**Bureau of
Development
Services** FROM CONCEPT
TO CONSTRUCTION

Proposed Historic Resources Code Improvement Project Zoning Code Amendments

January 7, 2013

Figure 445-1 Facade Alterations

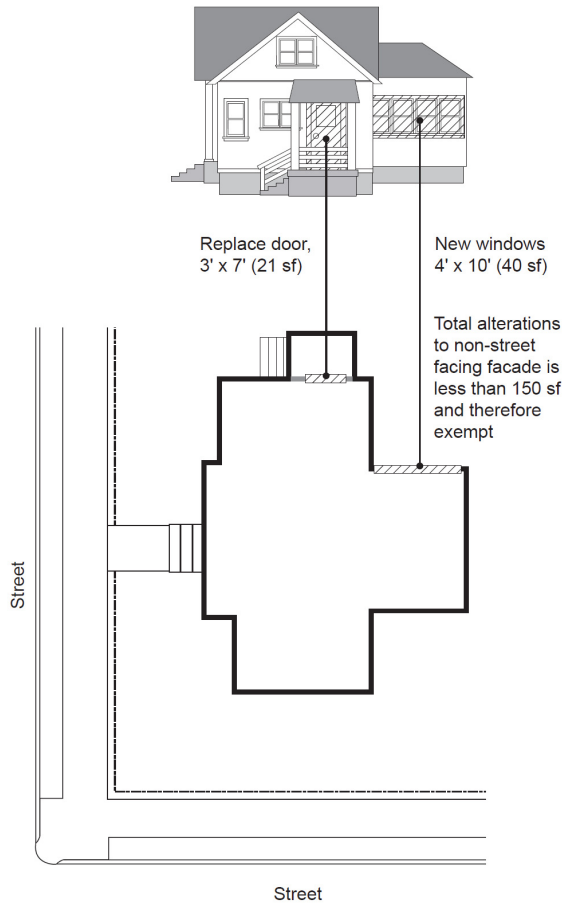
Figure 445-1 Facade Alterations

New figure added to illustrate new exemption in historic and conservation districts related to alterations to non contributing structures on non street-facing facades. See 33.445.320.B.3.

Figure 445-2: Basement Windows Replacement

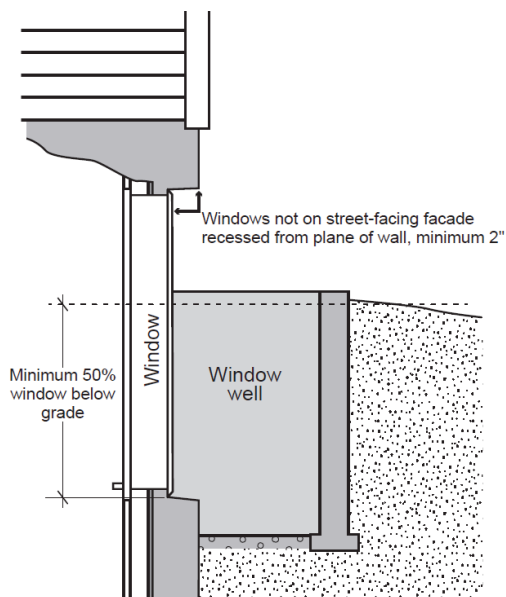
Figure 445-2: Basement Windows Replacement

New figure added to illustrate new exemption in historic and conservation districts related to alterations to non contributing structures on non street-facing facades. See 33.445.320.B.4.

Figure 445-3: Solar Energy System, Skylight and Roof Hatch Location on Rooftop

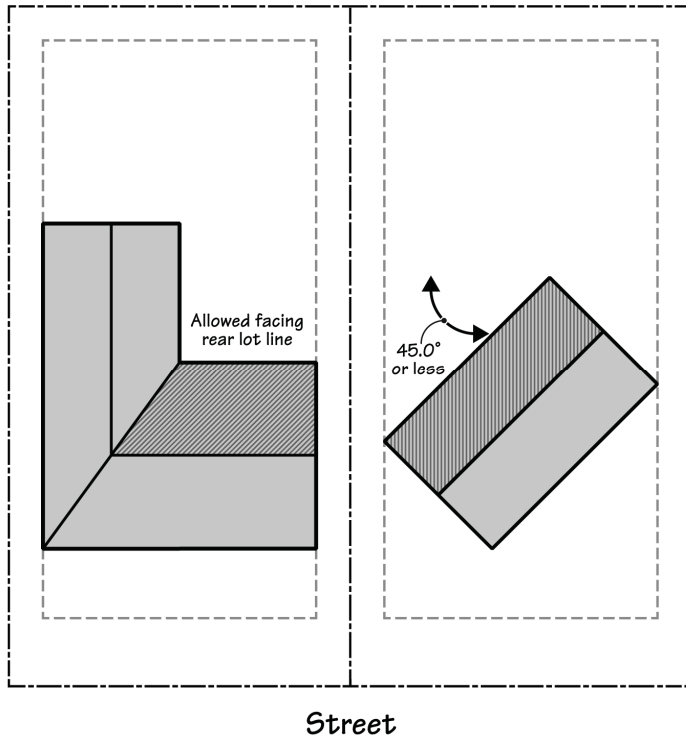
Figure 445-3: Solar Energy System, Skylight and Roof Hatch Location on Rooftop
Existing figure from 33.445. Renumbered and renamed to include reference to skylights and roof hatches.

Figure 445-4: Solar Energy Systems, Skylights and Roof Hatches on a Pitched Roof

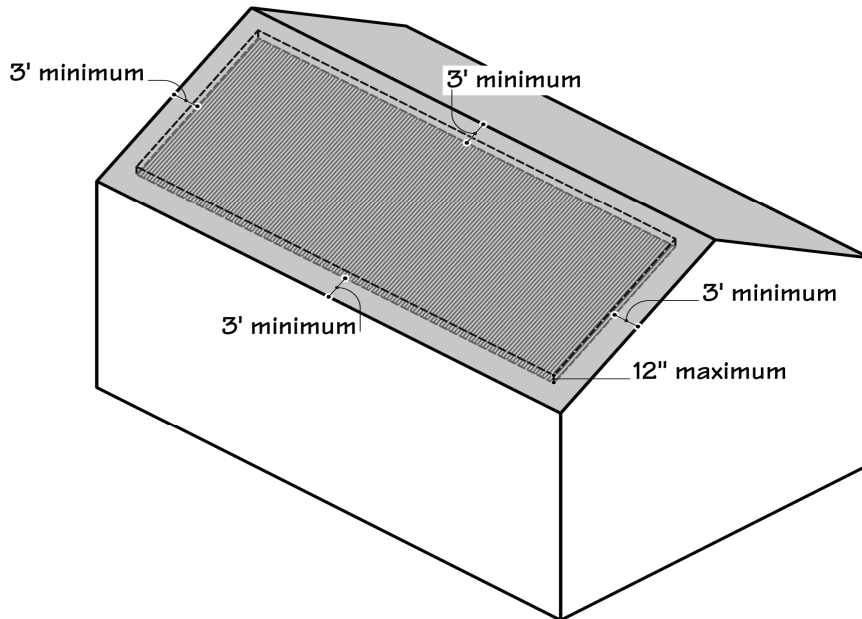
Figure 445-4: Solar Energy Systems, Skylights and Roof Hatches on a Pitched Roof
Existing figure from 33.445. Renumbered and renamed to include reference to skylights and roof hatches.
